**Economic and Social Council**Distr.: General  
3 November 2015

**Light vehicles – Global Technical****Regulation No. 15 on Worldwide harmonized****Light vehicles Test Procedure (WLTP)****Proposal for amendments to global technical regulation  
No. 15 on Worldwide harmonized Light vehicles Test  
Procedure (WLTP)****Submitted by the Informal Working Group on Worldwide harmonized  
Light vehicles Test Procedure (WLTP)\***

The text reproduced below was prepared by the Informal Working Group (IWG) on Worldwide harmonized Light vehicles Test Procedure (WLTP) in line with Phase 1B of its mandate (ECE/TRANS/WP.29/AC.3/39). A first draft of this proposal (GRPE-71-25 and GRPE-71-26) was introduced by the IWG on WLTP at the seventy-first session of GRPE (see report ECE/TRANS/WP.29/GRPE/71, paras. 14-16). The modifications to the current text of global technical regulation No. 15 are marked in track changes.

Figure A1/44**15**

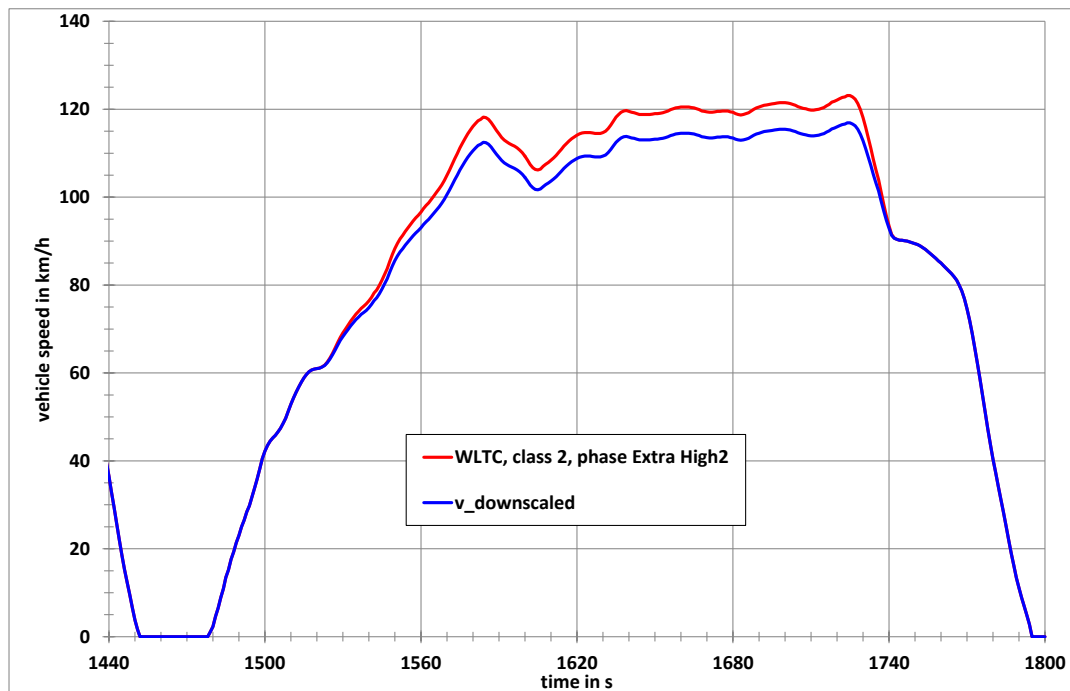
Since the driveability problems are exclusively related to the extra high speed phases of the Class 2 and Class 3 cycles, the downscaling is related to those paragraphs of the extra high speed phases where the driveability problems occur (see Figure A1/44**15**).

Figure A1/45-16  
Downscaled extra high speed phase of the Class 3 WLTC

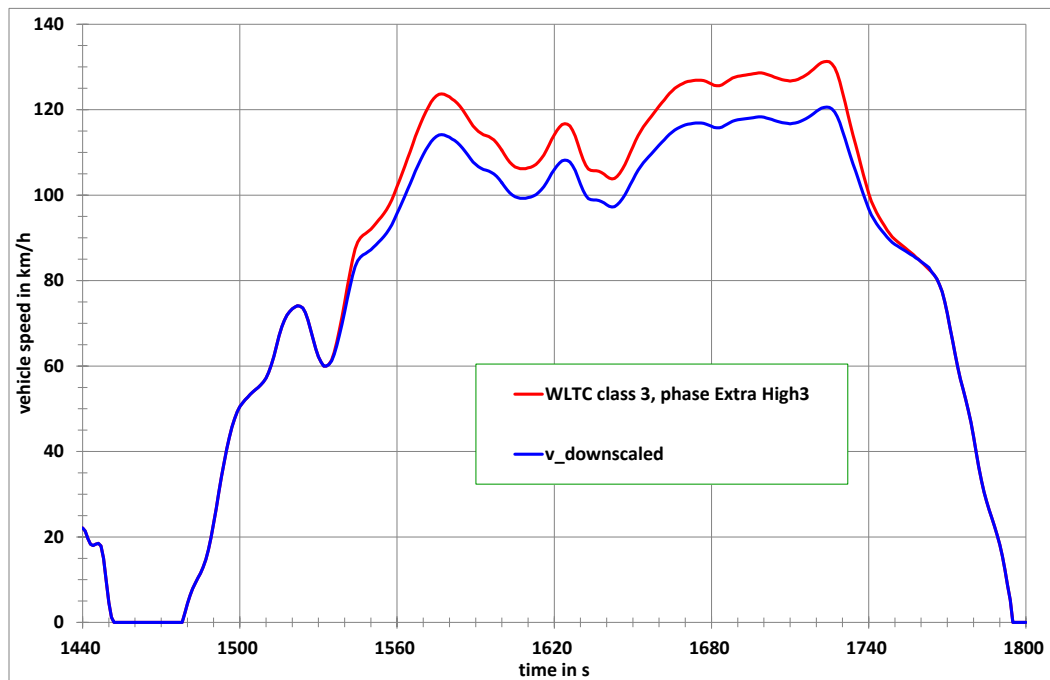
Figure A1/45-16 shows an example for a downscaled extra high speed phase of the Class 3 WLTC.

Figure A5/4

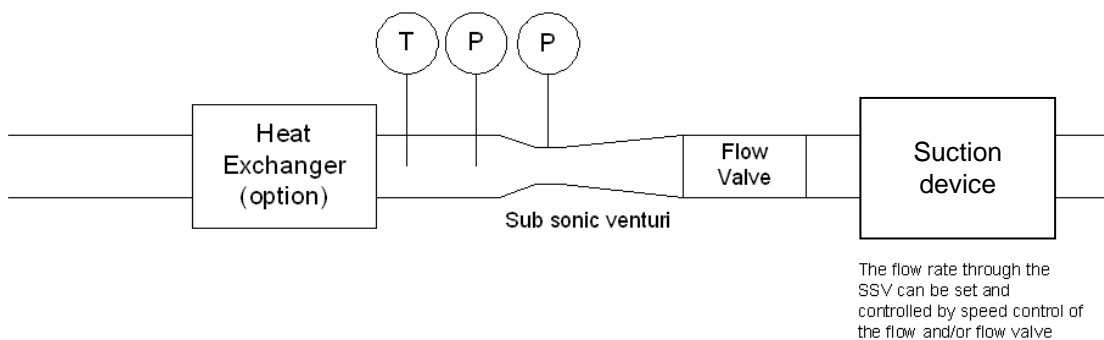
- 3.3.6.3.1. The use of ~~an subsonic venturi~~ (SSV) (**Figure A5/4**) for a **full flow exhaust full flow** dilution system is based on the principles of flow mechanics. The variable mixture flow rate of dilution and exhaust gas is maintained at a subsonic velocity ~~which~~ **that** is calculated from the physical dimensions of the subsonic venturi and measurement of the absolute temperature (**T**) and pressure (**P**) at the venturi inlet and the pressure in the throat of the venturi. Flow is continually monitored, computed and integrated throughout the test.

**Schematic of a ~~subsonic V-venturi Tube-tube~~ (SSV)**

Figure A5/5

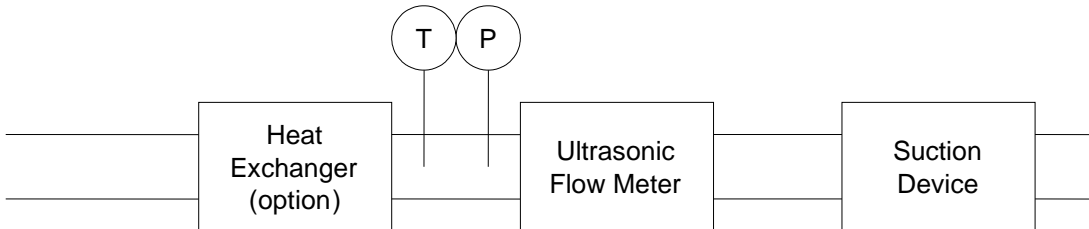
- 3.3.6.4. Ultrasonic flow meter (**UFM**~~USM~~)
- 3.3.6.4.1. **A UFM measures the velocity of the diluted exhaust gas in the CVS piping using the principle of ultrasonic flow detection by means of a pair, or multiple pairs, of ultrasonic transmitters/receivers mounted within the pipe as in Figure A5/5. The velocity of the flowing gas is determined by the difference in the time required for the ultrasonic signal to travel from transmitter to receiver in the upstream direction and the downstream direction. The gas velocity is converted to standard volumetric flow using a calibration factor for the tube diameter with real time corrections for the diluted exhaust temperature and absolute pressure.**~~A USM measures the velocity of the diluted exhaust gas using ultra-sonic transmitters/detectors as in Figure A5/5. The gas velocity is converted to standard volumetric flow using a calibration factor for the tube diameter with real time corrections for the diluted exhaust temperature and absolute pressure.~~

**Schematic of an ultrasonic flow meter (UFM<sub>USM</sub>)**

Figure A6/1  
**Flowchart for the nNumber of Type 1 tests**

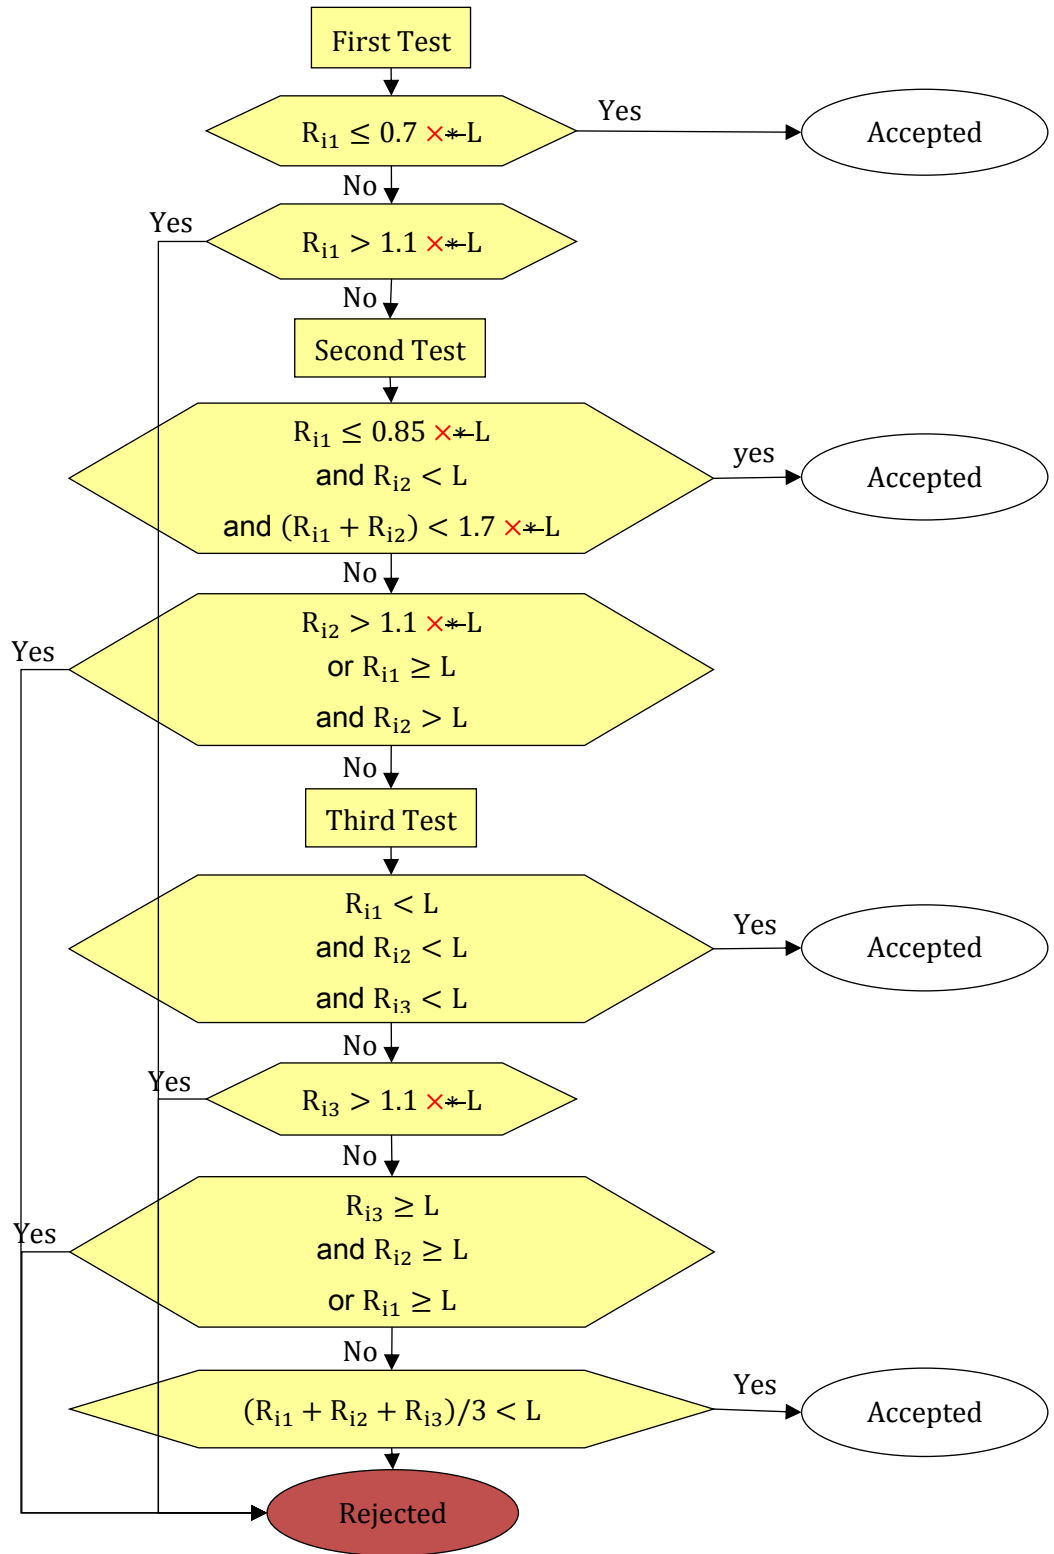
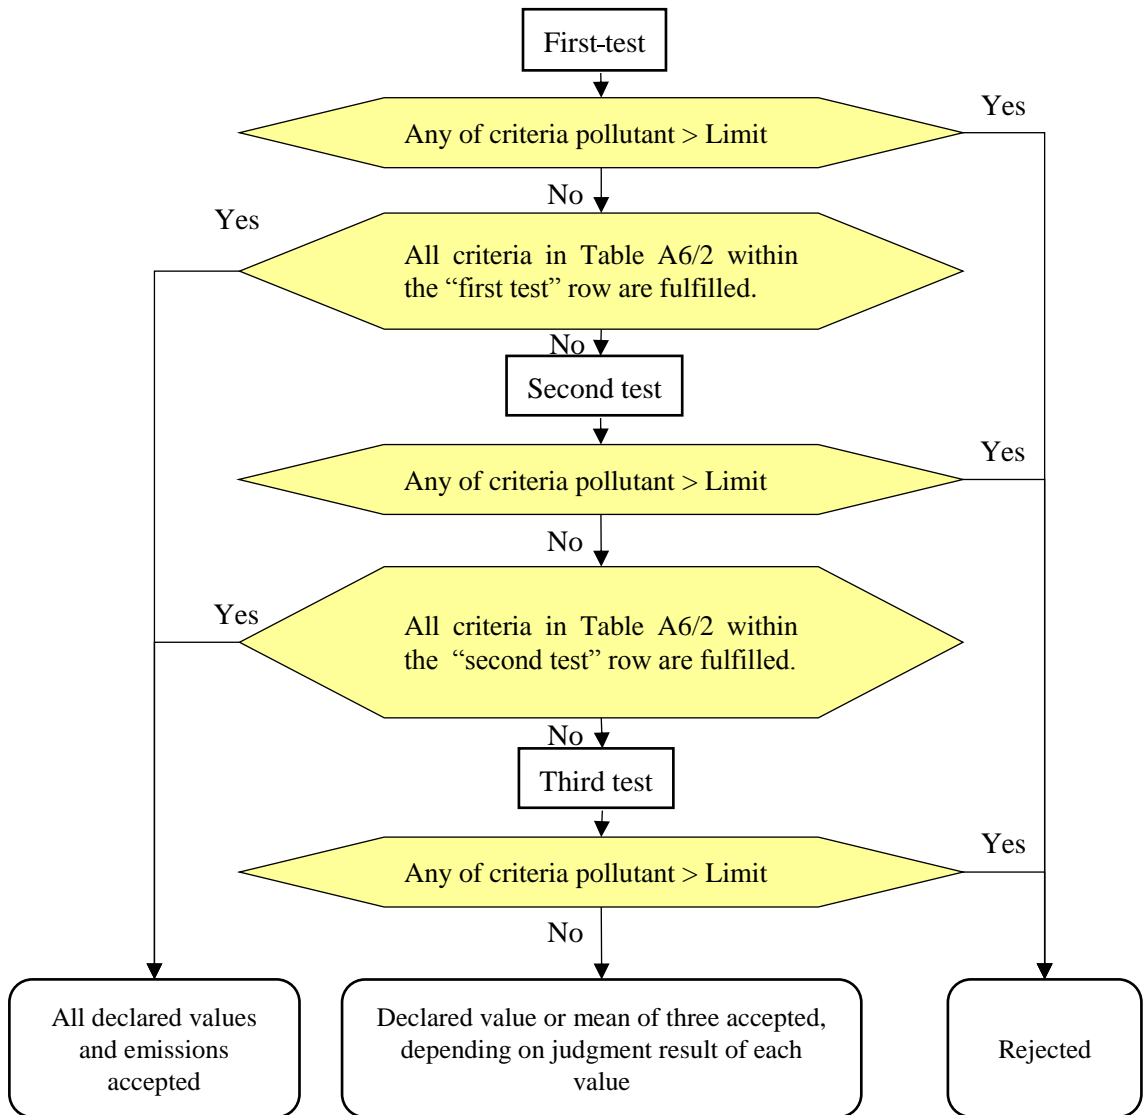
~~The number of tests shall be determined as shown in Figure A6/1.  $R_{11}$  to  $R_{13}$  describe the final measurement results of three tests to determine gaseous compounds, particulate matter, particle number, CO<sub>2</sub> emissions, and fuel consumption where applicable.  $L$  are limit values as defined by the Contracting Parties. If a vehicle configuration must be driven more than once to show compliance with regional limits (as defined in Figure A6/1), the average CO<sub>2</sub> value must be calculated. for type approval.~~

- 1.1.2.1. **The flowchart in Figure A6/1 shall be applicable only to the whole applicable WLTP test cycle and not to single phases.**
    - 1.1.2.2. **The test results shall be the values after the REESS energy change-based,  $K_i$  and other regional corrections (if applicable) are applied.**
